The Commission has issued the enclosed Amendment No. 50 to Provisional Operating License No. DPR-19 for Dresden Station Unit 2 and Amendment Nos. 59 and 54 to Facility Operating License Nos. DPR-29 and DPR-30 for Quad Cities Station Units 1 and 2, respectively. The amendments are in response to your letter of March 19, 1980.

The amendments establish MAPLHGR limits for standard 8x8 (8D250 and 8D262) fuel types for exposure values beyond those currently given in the Technical Specifications.

SAFETY EVALUATION BY THE OFFICE OF NUCLEAR REACTOR REGULATION
SUPPORTING AMENDMENT NO. 50 TO PROVISIONAL OPERATING LICENSE NO. DPR-19,
AMENDMENT NO. 59 TO FACILITY OPERATING LICENSE NO. DPR-29, AND
AMENDMENT NO. 54 TO FACILITY OPERATING LICENSE NO. DPR-30

FIGURE 3.5-1
(Sheet 1 of 1)

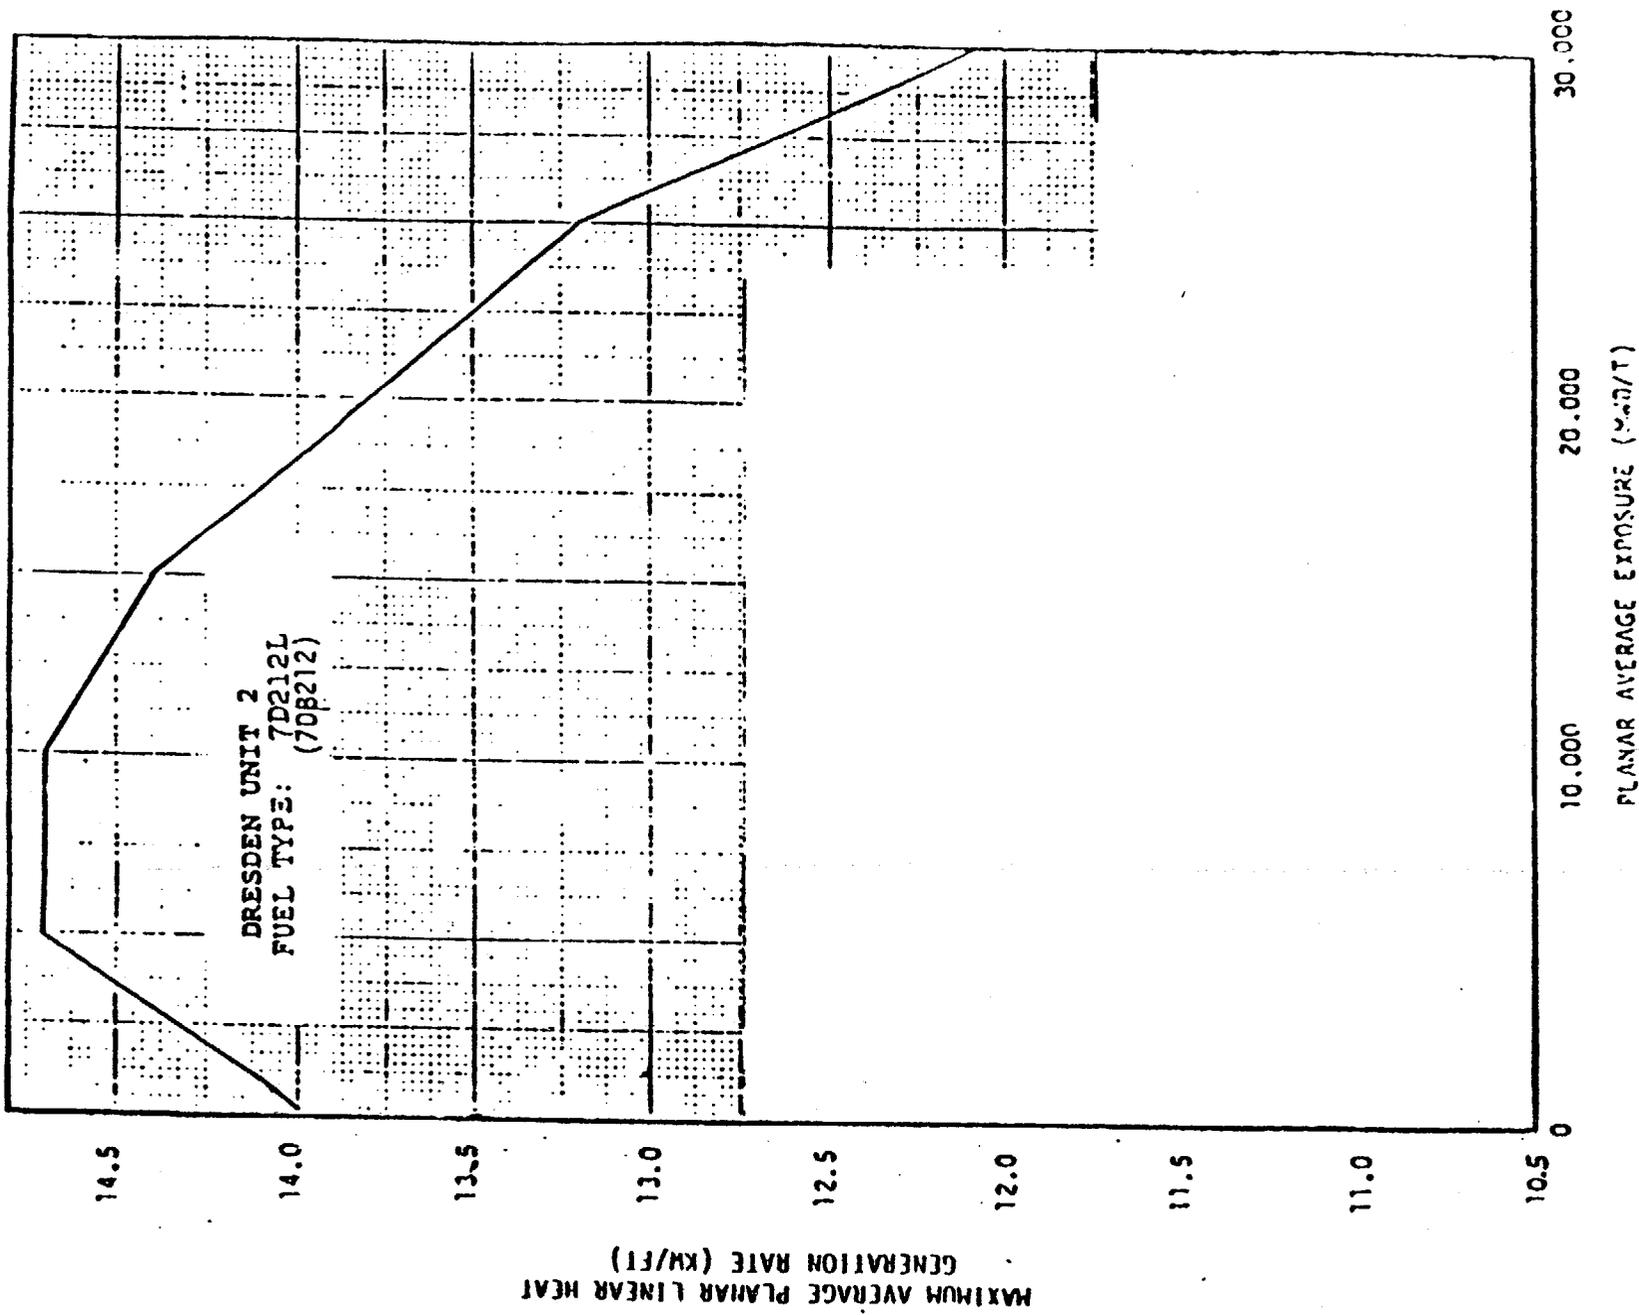
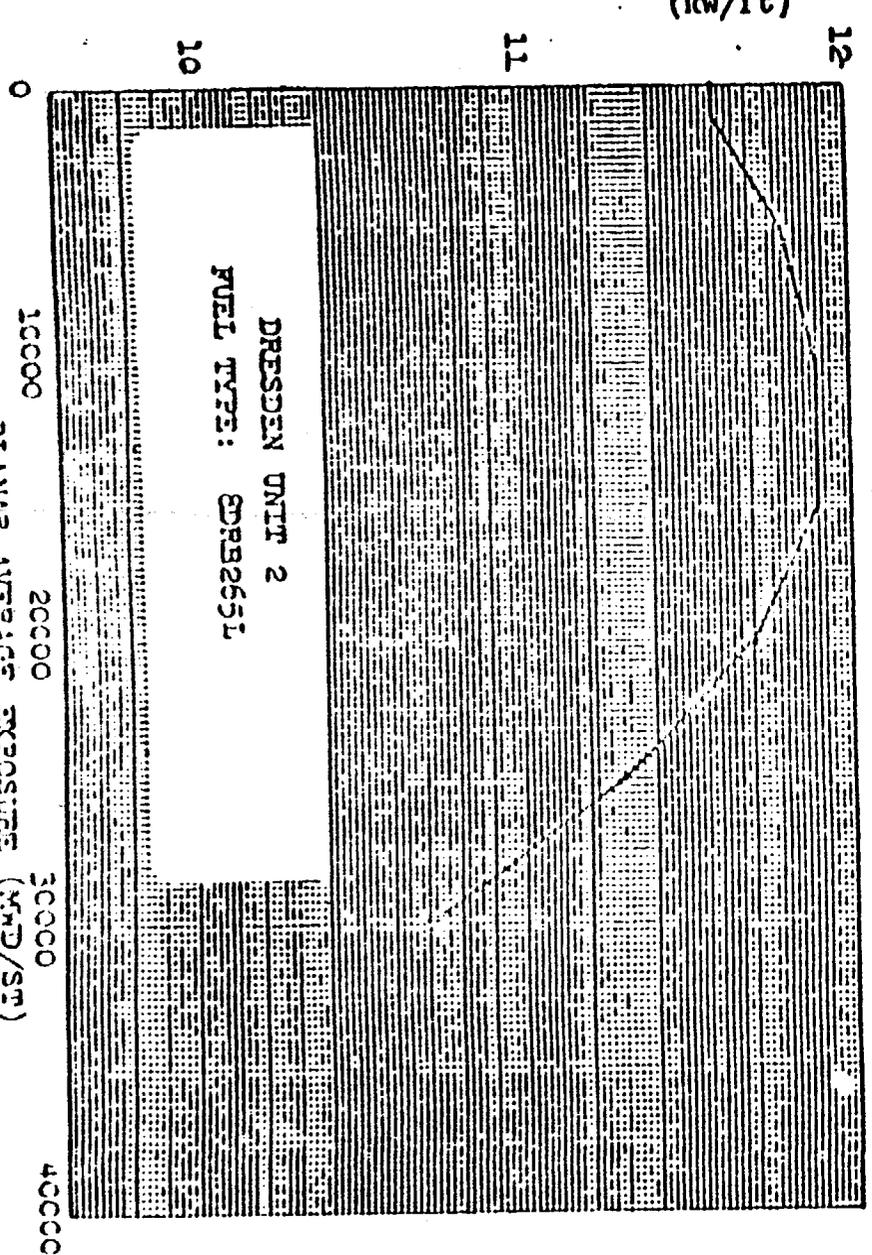
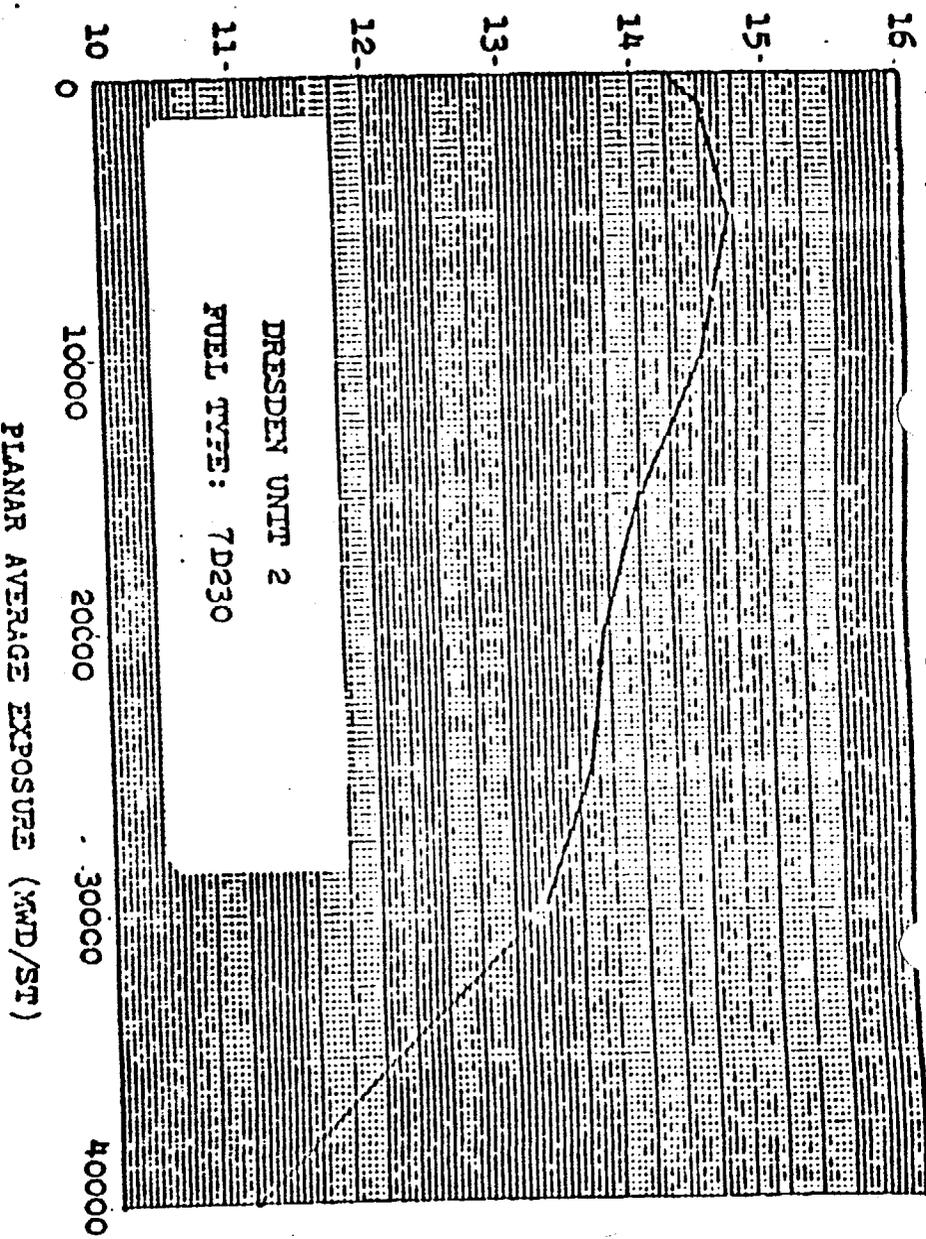
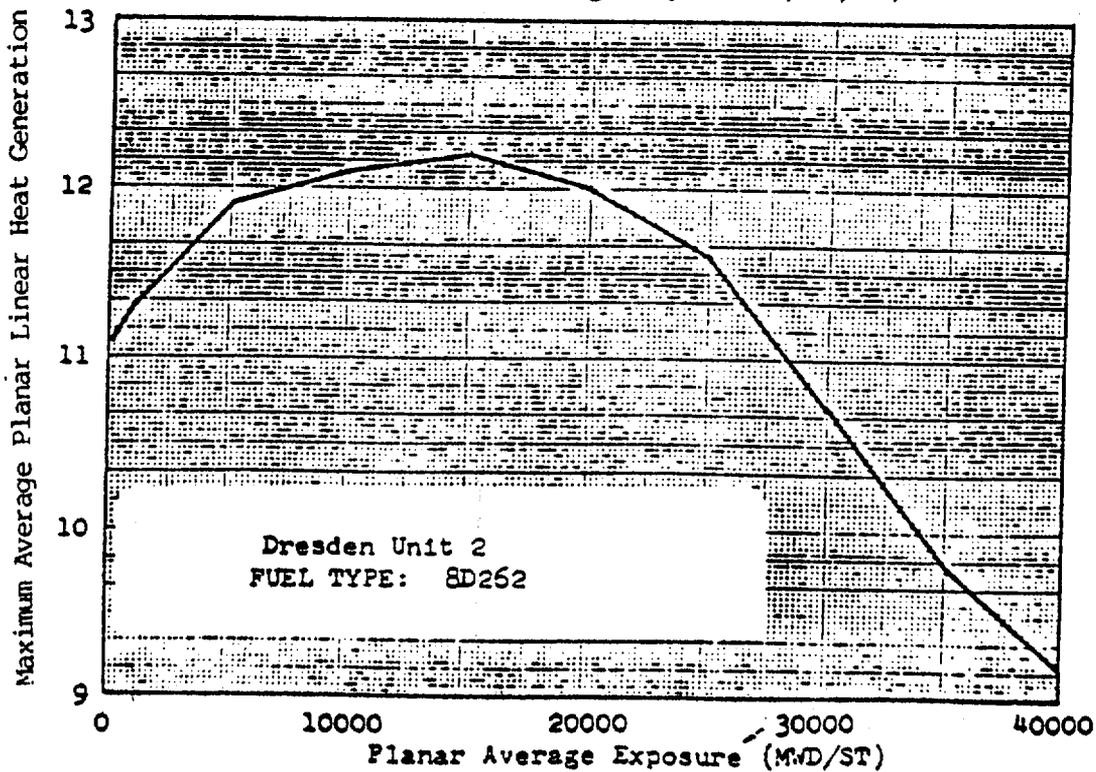
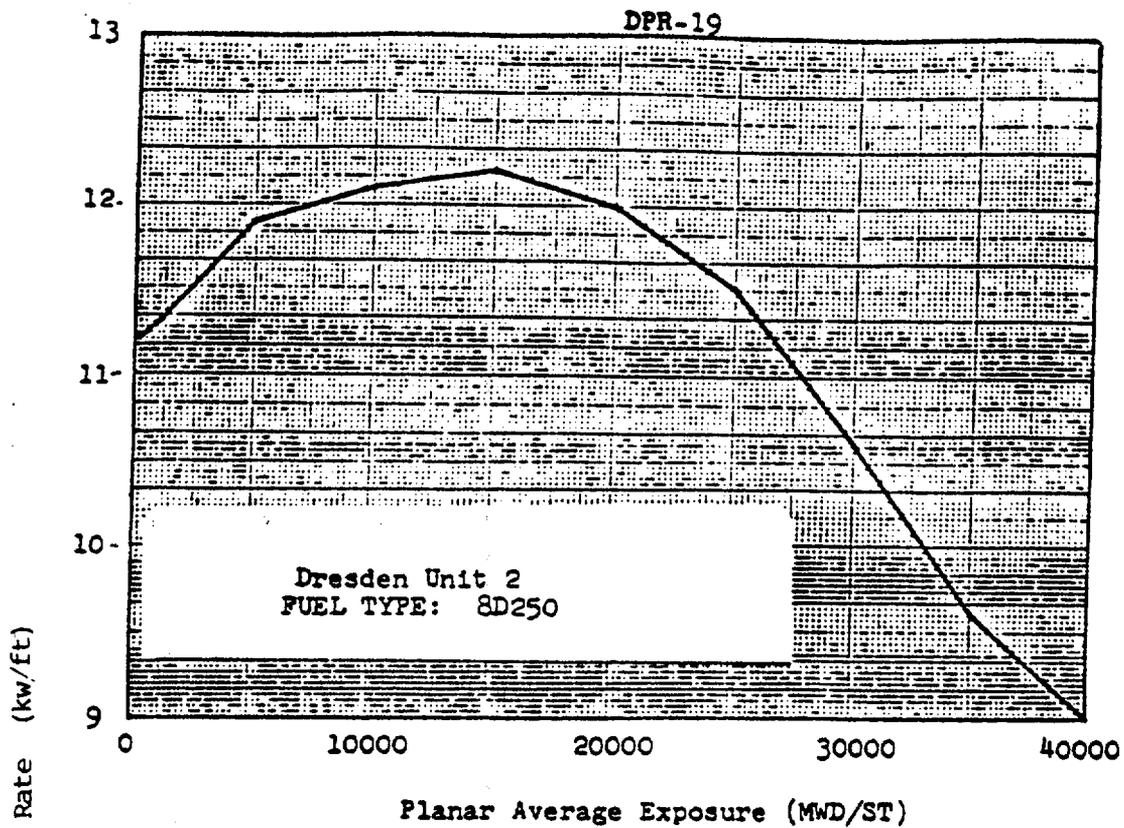
During steady state power operation, the average linear heat generation rate (LHGR) of all the rods in any fuel assembly, as a function of average planar exposure, at any axial location, shall not exceed the maximum average planar LHGR shown in Figure 3.5-1 dependent on fuel type. If at any time during operation it is determined by normal surveillance that the limiting value for APLHGR is being exceeded, action shall be initiated within 15 minutes to restore operation to within the prescribed limits. If the APLHGR is not returned to within the prescribed limits within two (2) hours, the reactor shall be brought to the Cold Shutdown condition within 36 hours. Surveillance and corresponding action shall continue until reactor operation is within the prescribed limits.
